Whites Point Quarry & Marine Terminal

REVISED PROJECT DESCRIPTION

Whites Point Quarry
 Little River, Digby County
 Nova Scotia

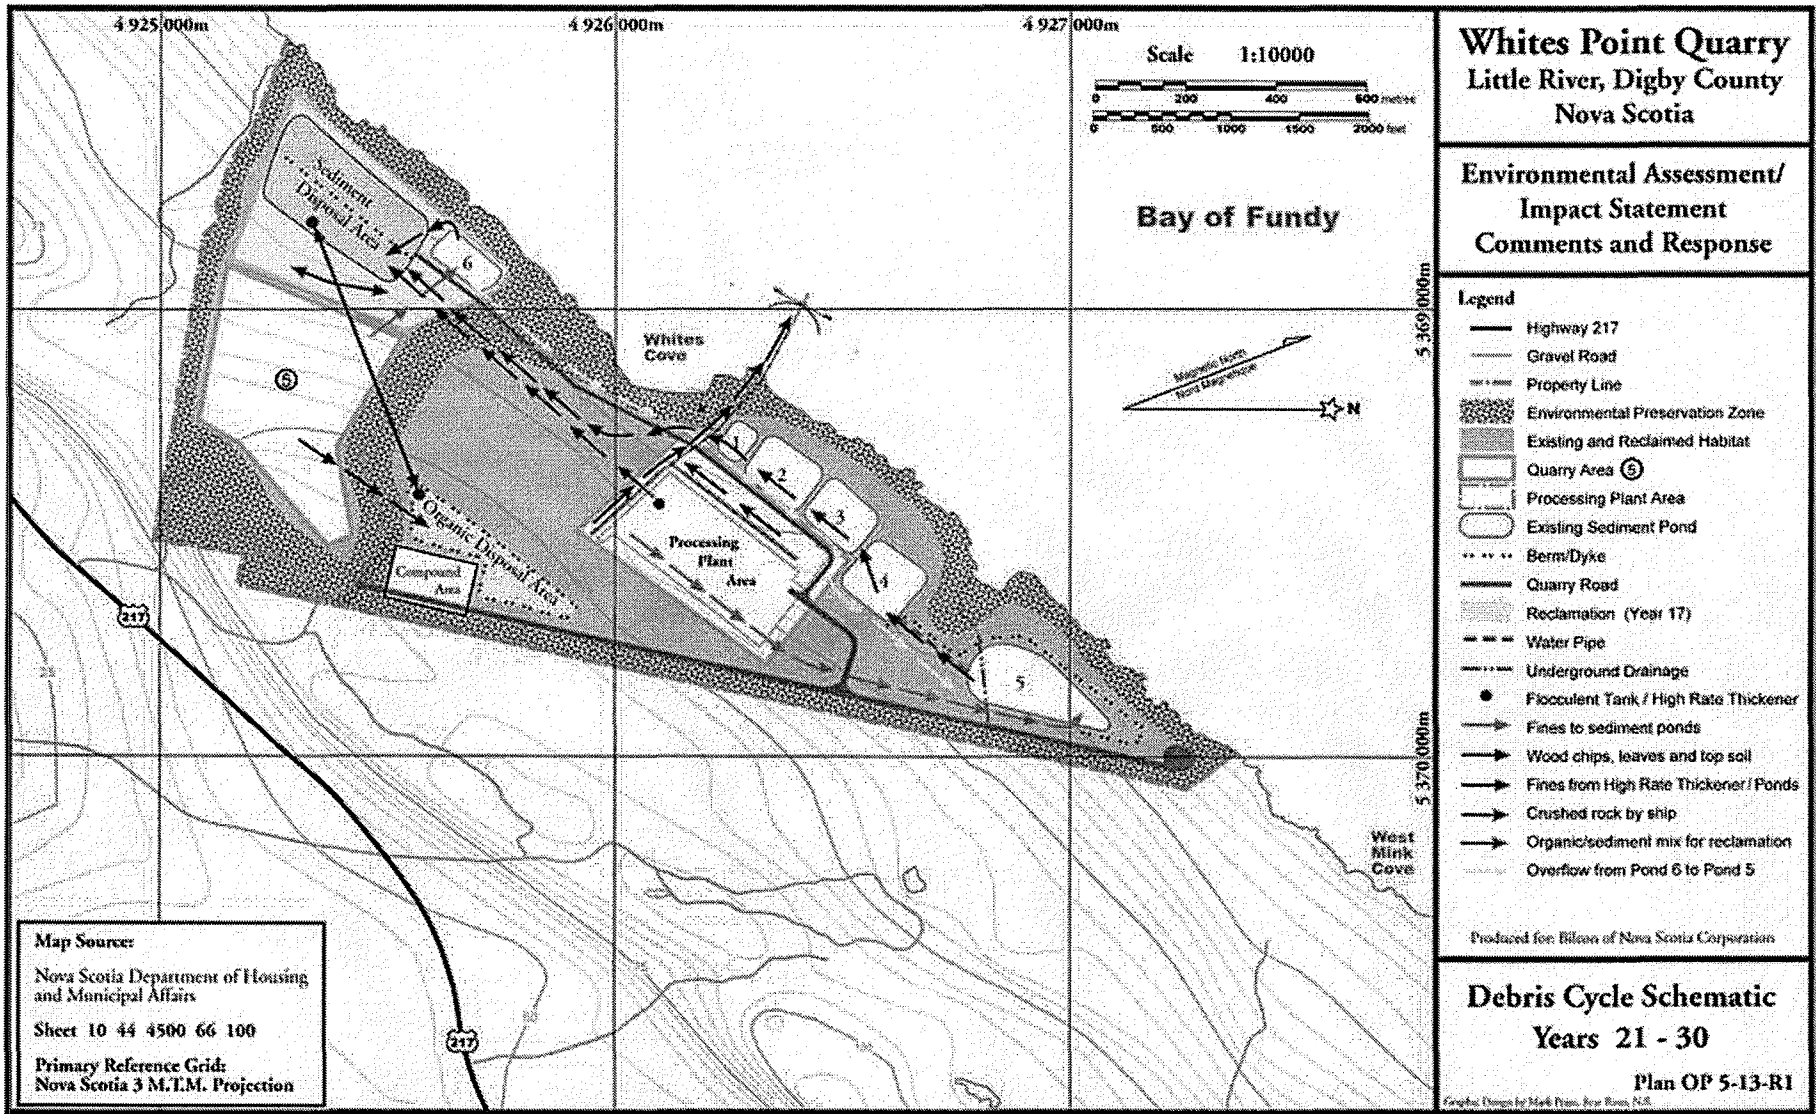
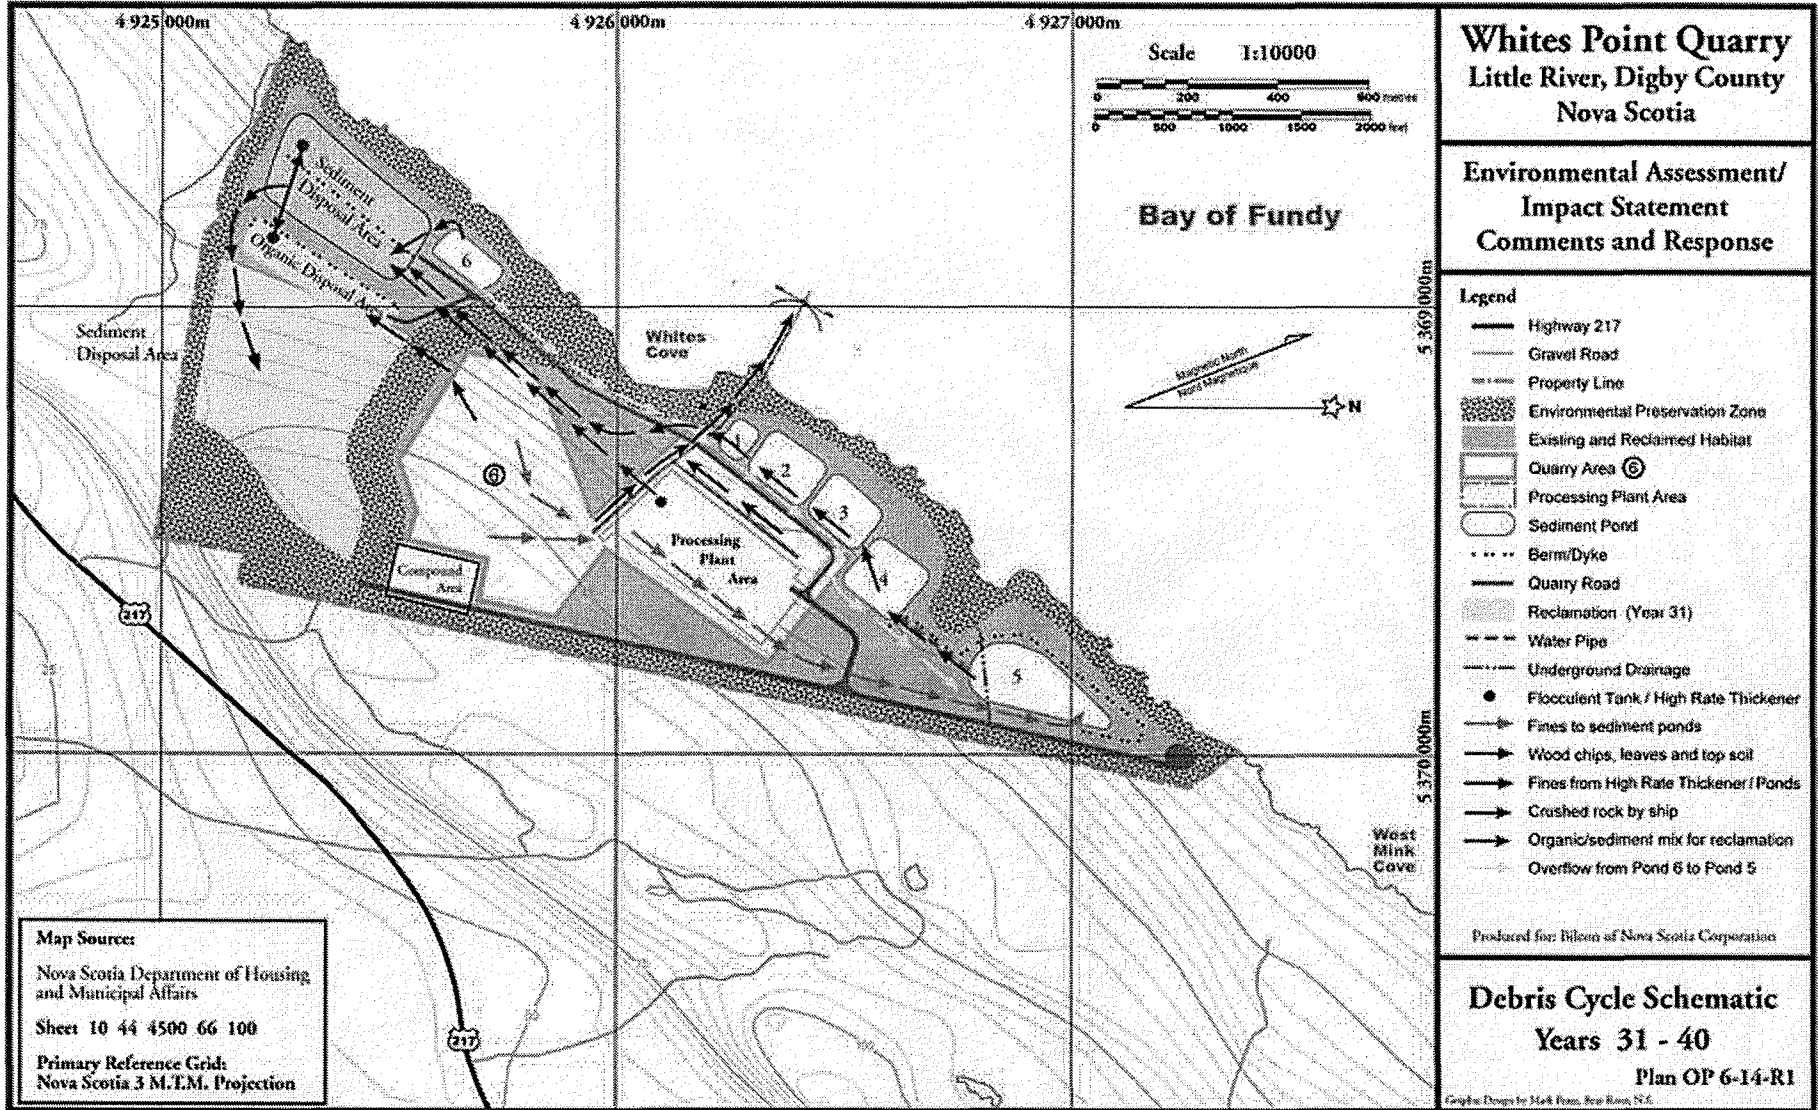
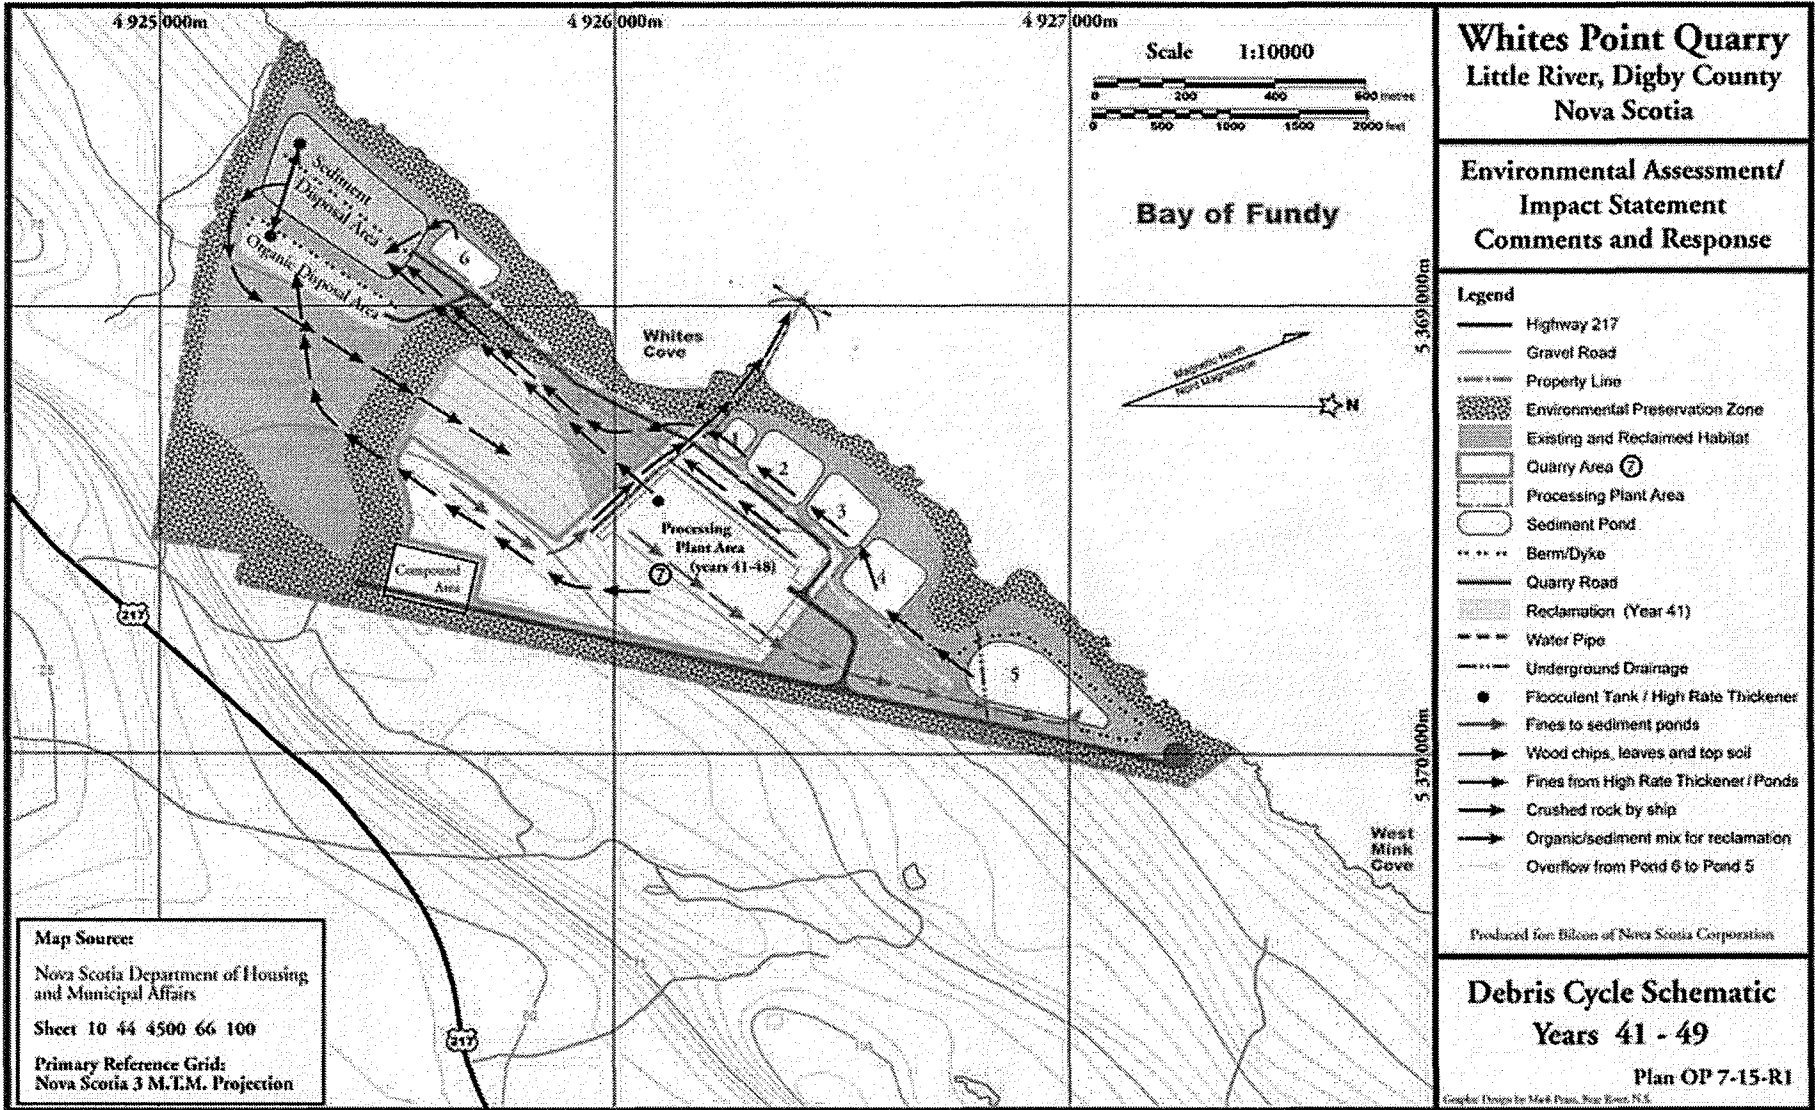
In view of the planned component relocations of the quarry operations, how can subsequent five-year plans be similar? Provide the five-year plans for subsequent periods.

The debris remaining from the crushing process will initially be stored in designated areas and subsequently used in the reclamation process. **Plan OP1-9 – Debris Cycle Schematic** shows the track of debris for the initial 1-5 years of the quarry operation. Subsequent five year periods are shown in **Plans OP1-9-R1 through OP7-15-R1**.

Topsoil and chips from the clearing and grubbing process will be transported to the organic disposal area in the southeast corner of the site for temporary storage in years 1-30 and to the disposal area to the south side in years 30-50. These areas will be bermed to prevent material washing further down the slope.

Fines from the exposed operations area will be collected in the settling ponds which will be periodically emptied and the fines transported to the sediment disposal area in the easterly area of the site for temporary storage.

Fines from the washing operation will be directed to the high rate thickener where, following dewatering, they will be pumped to the sediment disposal areas to the south side for temporary storage. These sediment disposal area will be bermed to prevent migration of the fines further downslope.
